HEBRON PROJECT Comprehensive Study Report

Consolidated Comments

Combined Comments and Response Document

Figure 8-5 Offshore Study Area, Project Area and Other Zones

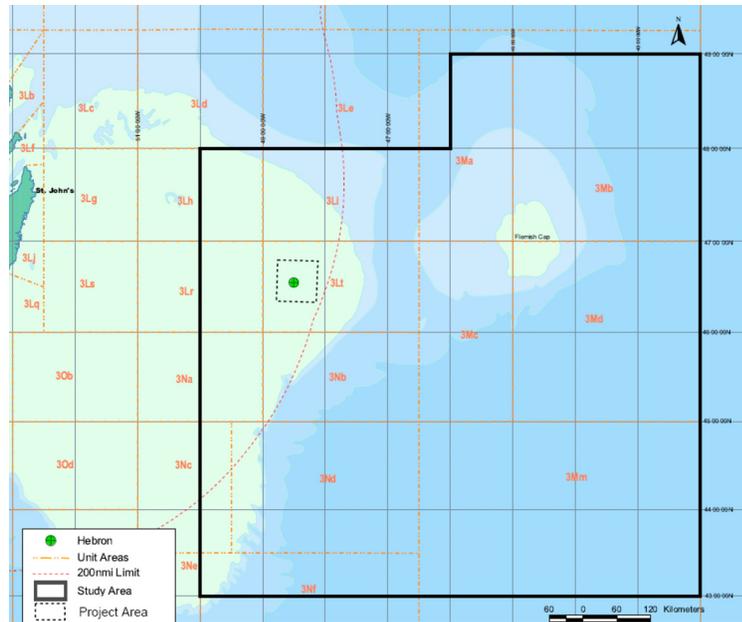
C2) 8.3.2 Offshore Fisheries; Page 8-14 Figure 8-5

NAFO unit area 3Na is mislabels as 3Lb.

EMCP Response 30-Nov-10: Corrected Figure 8-5 is provided as follows:

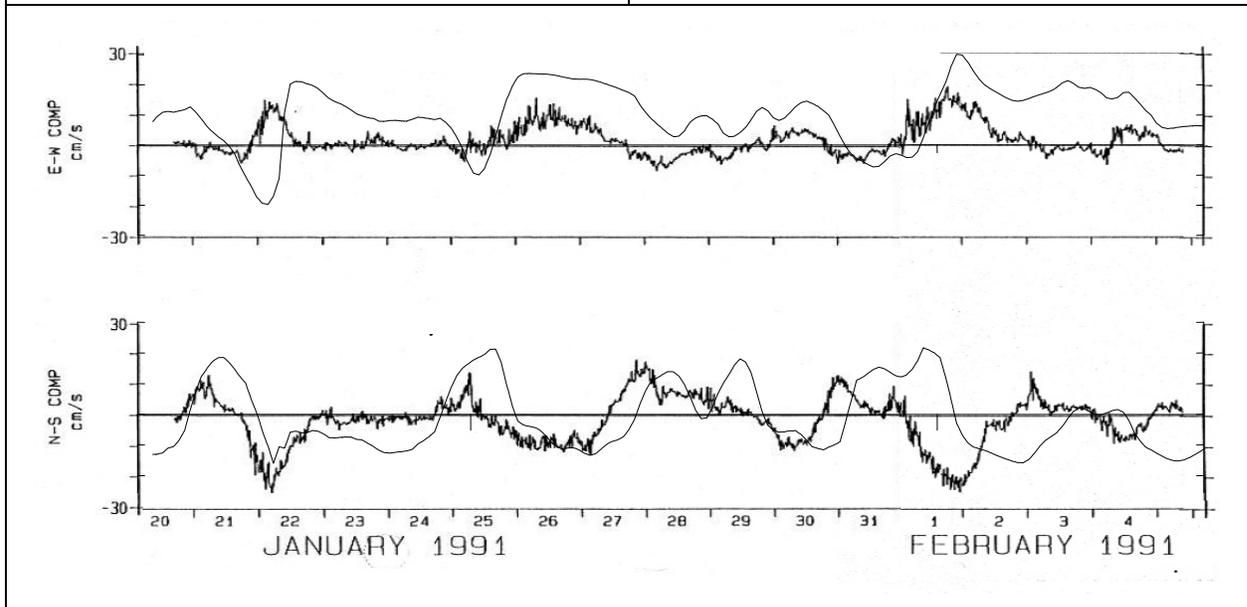
<p>Figure 2.5-9 (Page 20) It would be valuable to have these two plots overlaid so it can be seen how the model fits the data. By superimposing the print out versions, one can see model-data differences up to 50 cm/s for an event near January 21st. Model-data discrepancies appear to be around 10-20 cm/s leading to drift errors of 10-20 km per day.</p>	<p>The plot below shows the model predicted currents (smooth line) overlain on the measured currents at the Bull Arm site for the period January 20 through February 5. This figure will be included in the Nearshore Spill Trajectory Report. As can be seen in the plot, the agreement between the model predicted currents and the measured currents at the Bull Arm site show that the model both under-predicts and over-predicts currents at times. Considering the data over a 30-day period (the time frame for the oil spill simulations), the model predicted currents are doing a good job of representing flow at the site.</p>

Figure 3-13 Frequency Presence of Sea Ice in Trinity Bay

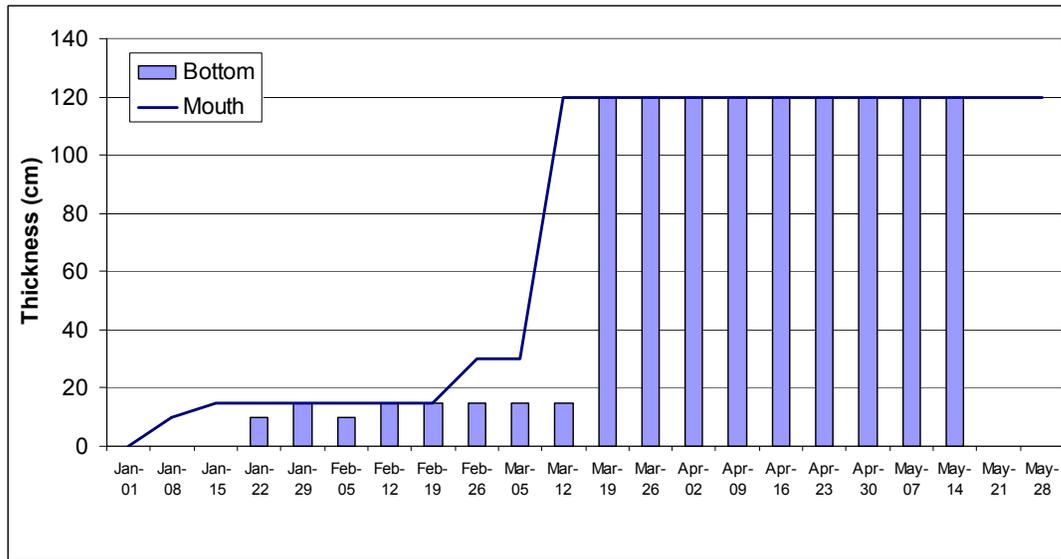
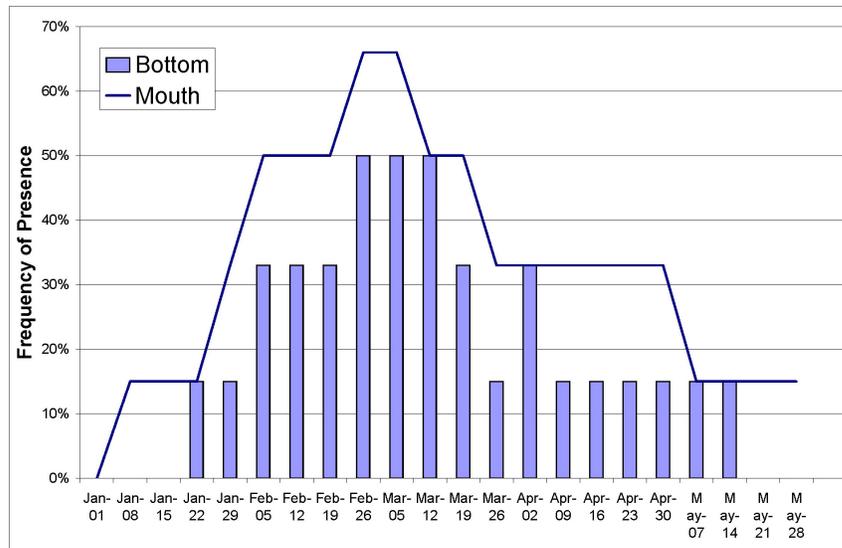
Comment A-3: *Figure 3-13: Inconsistencies/Errors in quoted Source:* in paragraph 1 of 3.1.4, you mention that ice charts from 1983-2008 were reviewed. For Figure 3-13, however, you quote the source as “Canadian Ice Service 2001”, which would refer to the “Canadian Ice Service Sea Ice Climatic Atlas: East Coast of Canada 1971-2000”. Further down, for Figure 3-14, you quote the source as “Canadian Ice Service weekly composite ice charts”. After reviewing the data in your graphs (Figures 3-13 and 3-14), it appears that you used the Ice Atlas data from 1971-2000 and not

Comment A-6: **Also, on both Figures 3-13 and 3-14, the data for the week of Feb 19 was erroneously skipped and replaced with that for the week of Feb 26. As a result, all weeks after Feb 19 contain the data for the following week and the whole time series is out by one week. These graphs need to be corrected / re-done.

EMCP Response 30-Nov-10: The revised figures will be provided in the CSR as follows:

Figure 3-13 will be revised as follows:

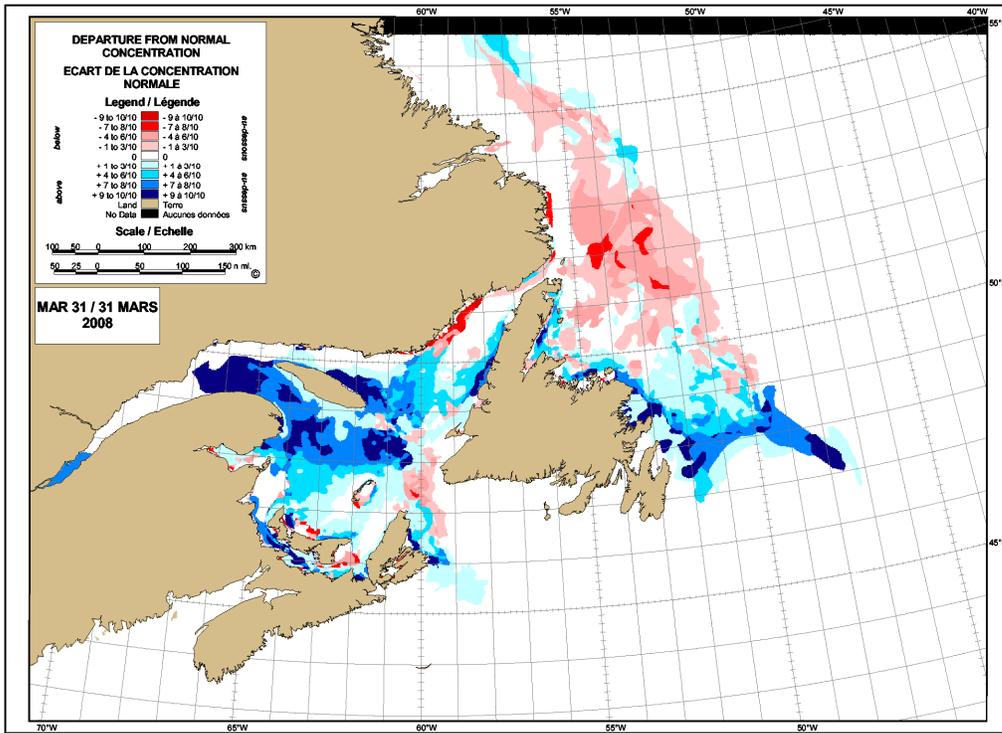
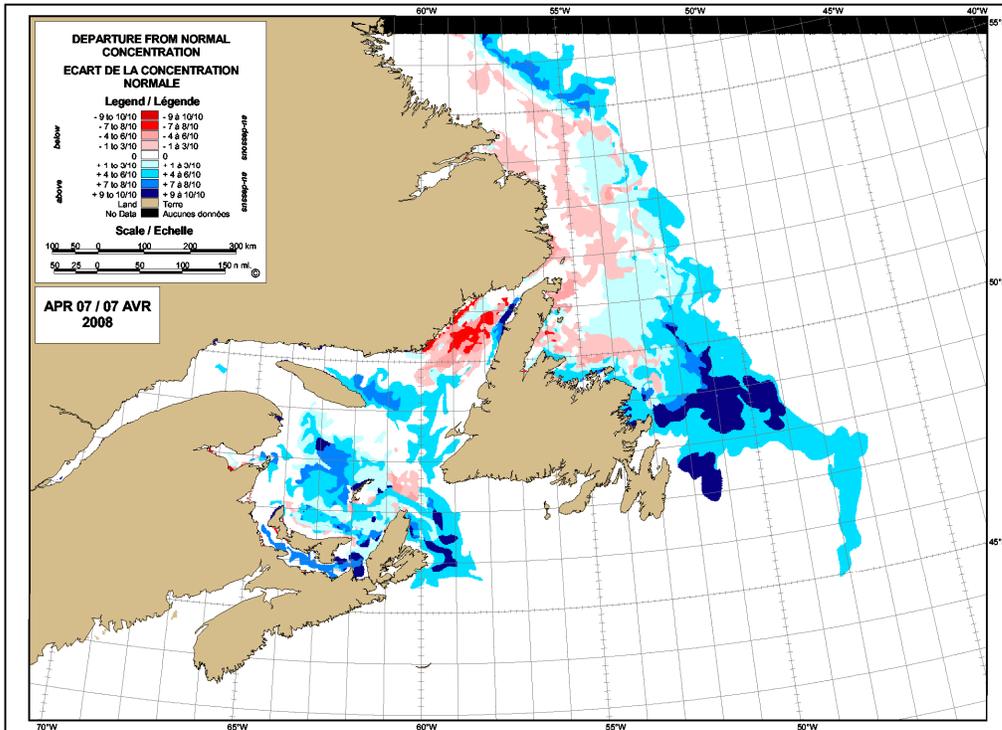
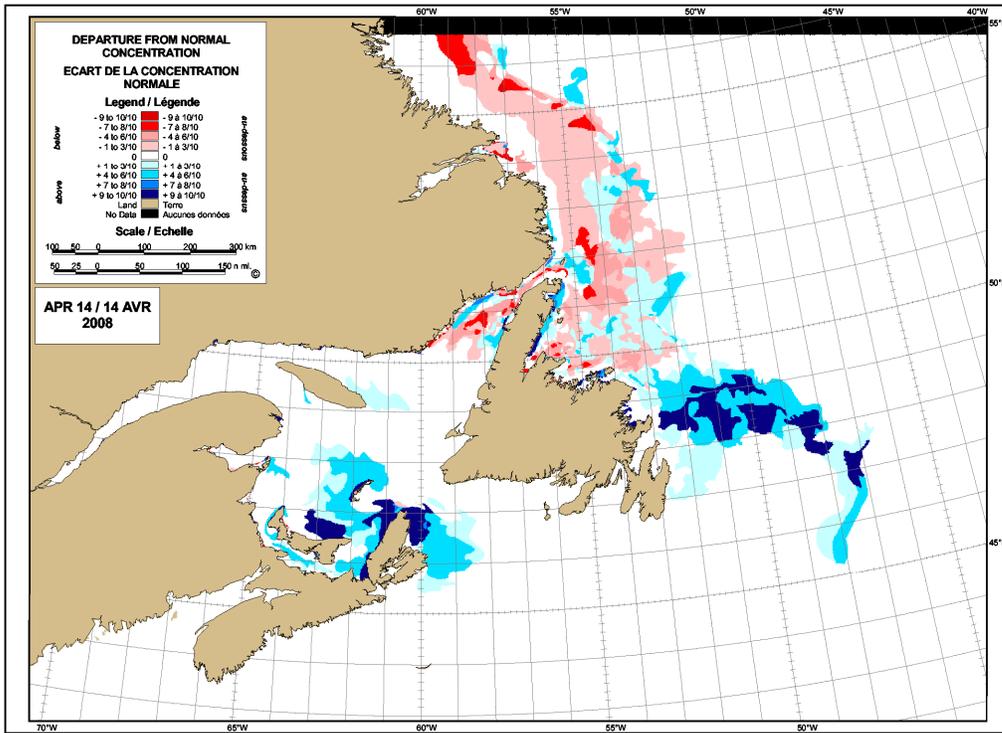
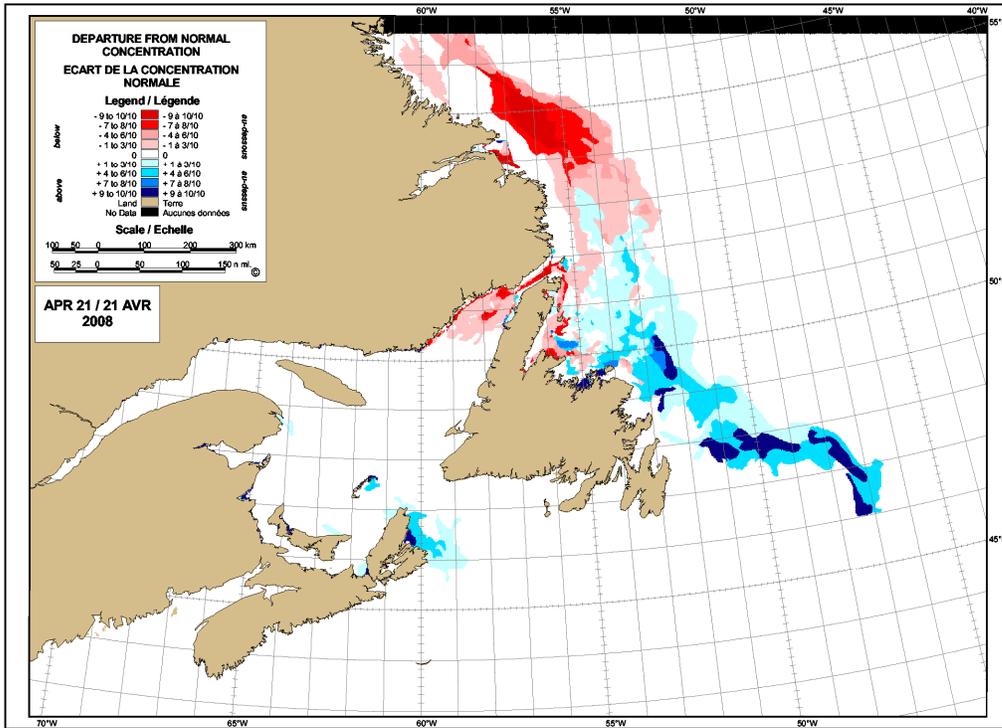
Comment A-14: Below is the series of departure-from-normal concentration sea ice charts showing the encroaching sea ice in the White Rose area over the period spanning end-of-March through April 2008:

EMCP Response 30-Nov-10: The CSR will be revised to include the departure from normal charts.

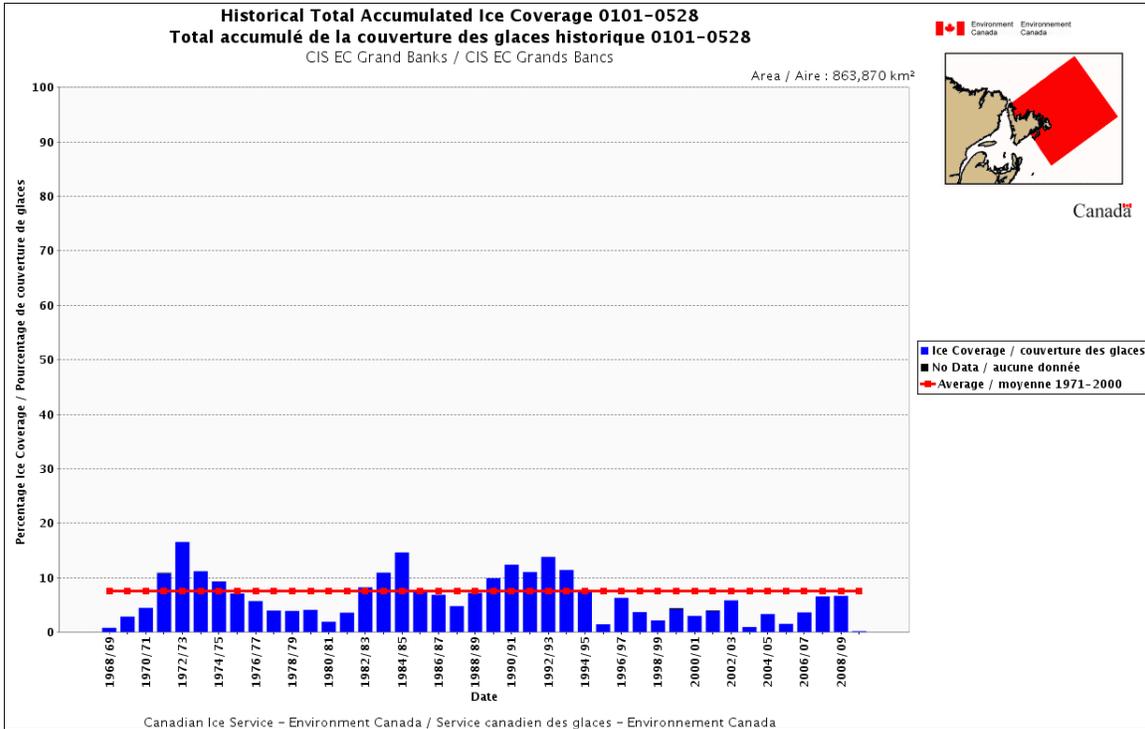
Comment A-19: *Figure 3-29:* This is not the “mid-month” chart for January. The charts for all the other months are for close to the 15th of that month, and in the text it says the included charts are for “mid-month”, so why not use the January 15th chart (below) as opposed to the January 8th chart (used in the study)? Replace Figure 3-29 with:

EMCP Response 30-Nov-10: Figure 3-29 will be replaced with above chart.

**Historical Total Accumulated Ice Coverage 0101 - 0528 /
Total accumulé de la couverture des glaces historique 0101 - 0528**

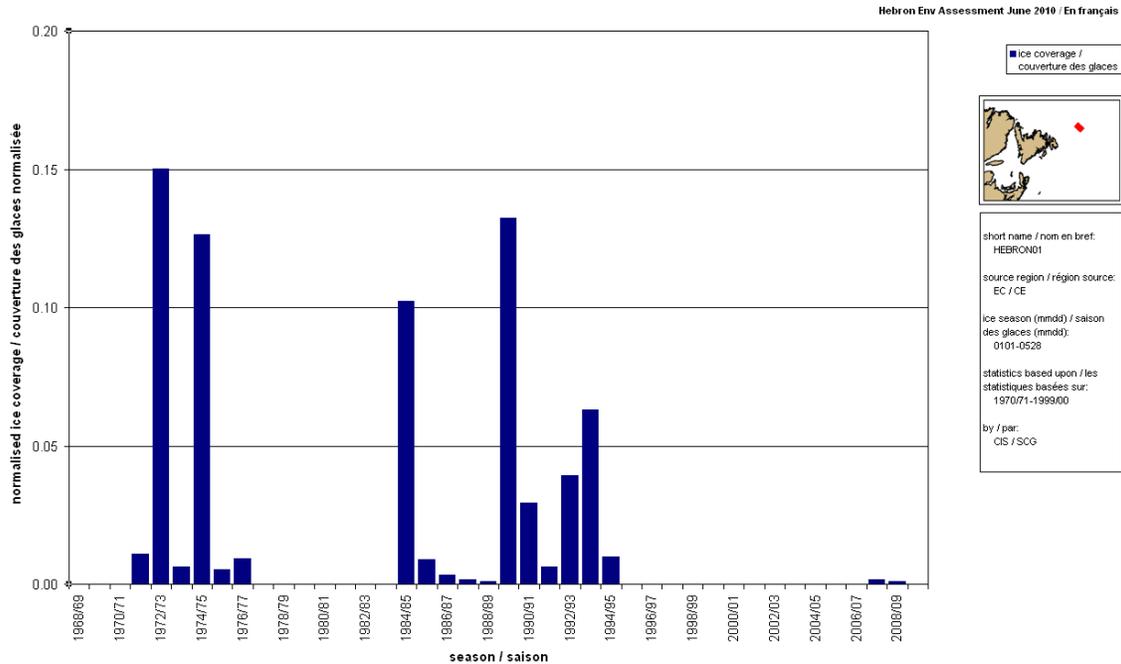
Comment A-21: CIS also has the capability of generating such ice graphs for areas not included in the web tool, if requested. It might also be good to include the following ice graph, tailored specifically to the Hebron Platform area. This graph also emphasizes that, based on 1969-2010 data, ice is only present in the area in approximately 19 years out of every 42 years (or in ~45% of the years). Based on 1971-2000 data, ice was present in that area in 57% of the years. The springs of 2008 and 2009 represented the first time ice was seen in that area within the last 15 years. (Note that the ice graph below shows an “Accumulated Ice Coverage” for the entire January to May period. Naturally, the “frequency of presence of sea ice” for the January to May period is higher than that for any individual month as shown in Figures 3-29 to 3-33).

The above ice graph also makes a nice progression between the larger Grand Banks area (Figure 3-34) and the area within a 15km radius of the platform (Figure 3-35).

EMCP Response 30-Nov-10: The above figure will be added to the CSR (new Figure 3-X).

Figure 3-35 Weekly Incursions of Sea Ice within 28 km of Hebron Platform Location

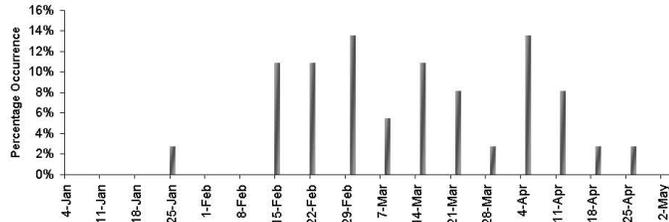
Comment A-22: Figure 3-35: In the text and in the caption, it says that this data is for within 15 km of the platform location, but in the title of the top graph of Figure 3-35 it says within 28 km of the platform. **Either the title or the Figure caption and text need to be corrected.**

Comment A-23: Also, in the table for Figure 3-35 it is not clear what the values within the grey boxes represent. If they represent the average concentration of ice within 28 km of the Hebron platform, then the column containing the Mean Concentration in the table contains errors. For example, for year 1991, values of 1, 9 and 4 are indicated. The mean value should then be 4.67, but the corresponding Mean concentration given in column 7 is “9”. On the other hand, if the values in the grey boxes represent “occurrence of ice within the 28km radius” as indicated in the column header, how can a value of 9 be obtained for a 7-day period? **The values in the table in Figure 3-35 need to be clearly defined and re-checked for errors.**

EMCP Response 30-Nov-10: Figure 3-35 will be revised as follows:

EMCP Response 18-Mar-11
 1. The source of the data in Figure 3-35 will be revised as follows:
 Source: CIS Ice Charts (1978 - 2008) and Field Observations (1972 - 2008)

Figure 3-X Tracks of Argo Drifter, 2002 to 2010

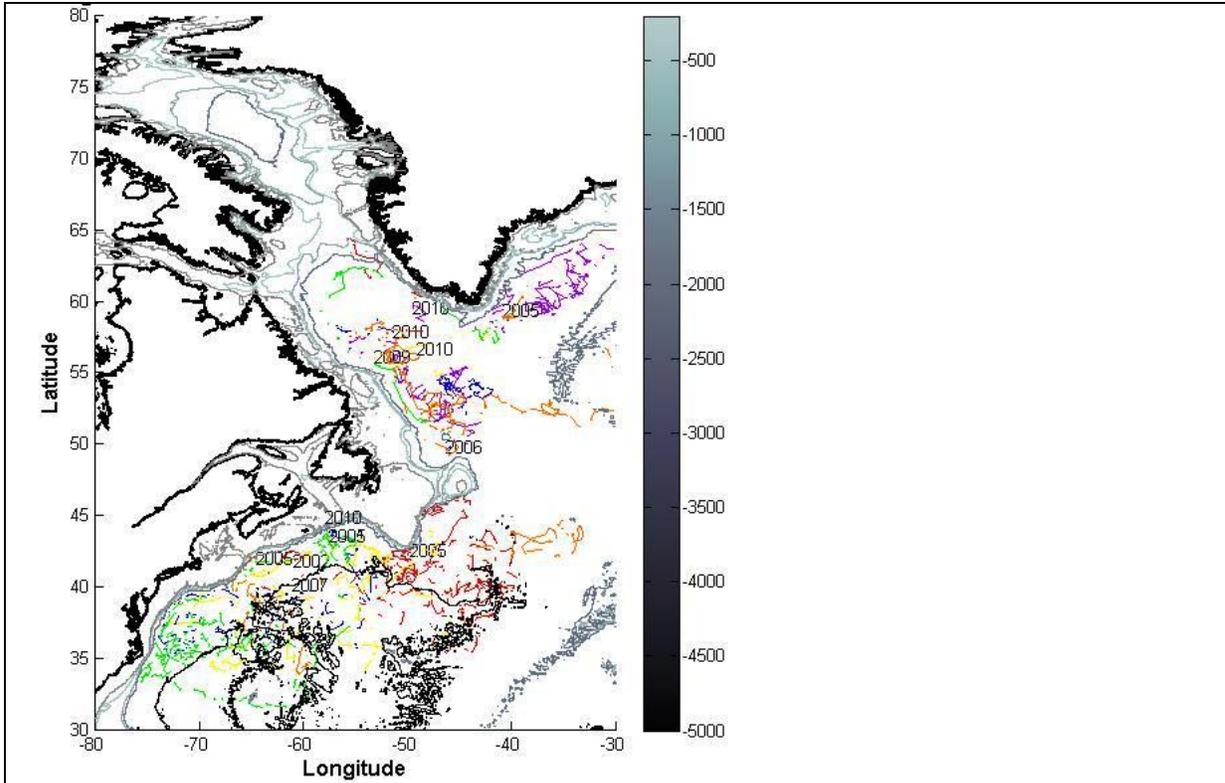
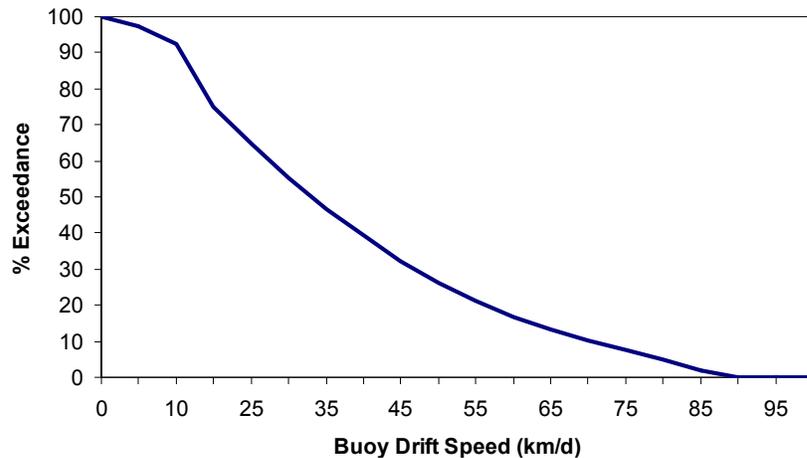
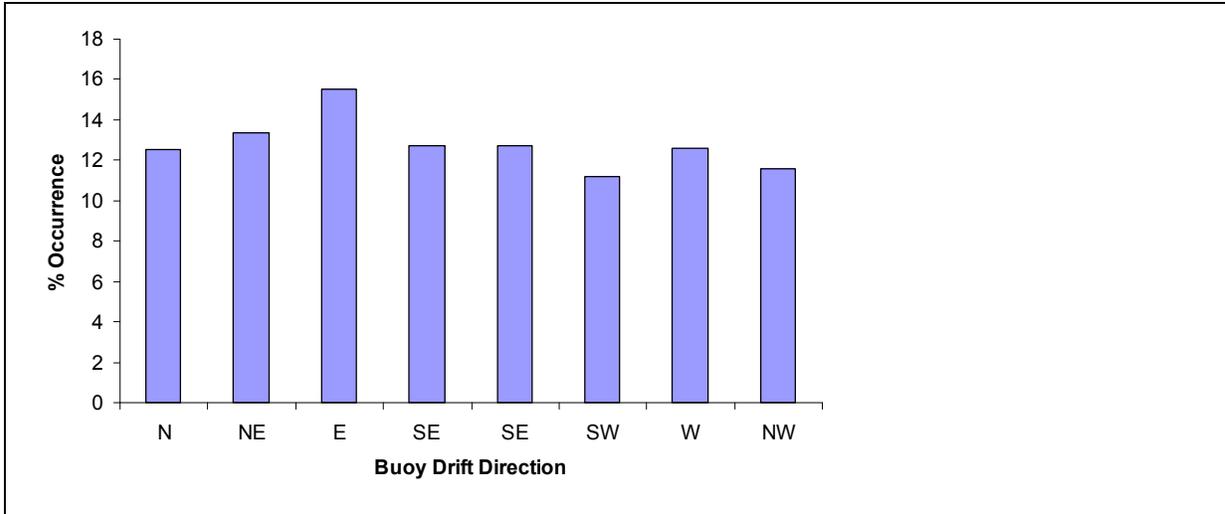
Comment A-27: *Para 2 and Figure 3-36: Inconsistent reference.* In the text it says the study was conducted over the period 1984-87 by Seaconsult Ltd. (1988), but in the figure itself it says “Data: February through April 1985” and references “Fissel et al. (1985)”.

EMCP Response 30-Nov-10: The following text will be added to Section 3.2.3.2

A verification study was carried out by Provincial Airlines Environmental Services Division with 18 Argo drifters from the years 2002 to 2010 in the North Atlantic Ocean, as obtained from the Integrated Science Data Management (ISDM) department of DFO. The spaghetti plot in Figure 3-X illustrates the tracks of these drifters. Each drift track is denoted by a different color line, with the year number indicating the point at which the drifter started transmitting data. Breaks in the lines indicate gaps in the data of five or more days, which may be a result of transmission errors or filtering of the data for quality control.
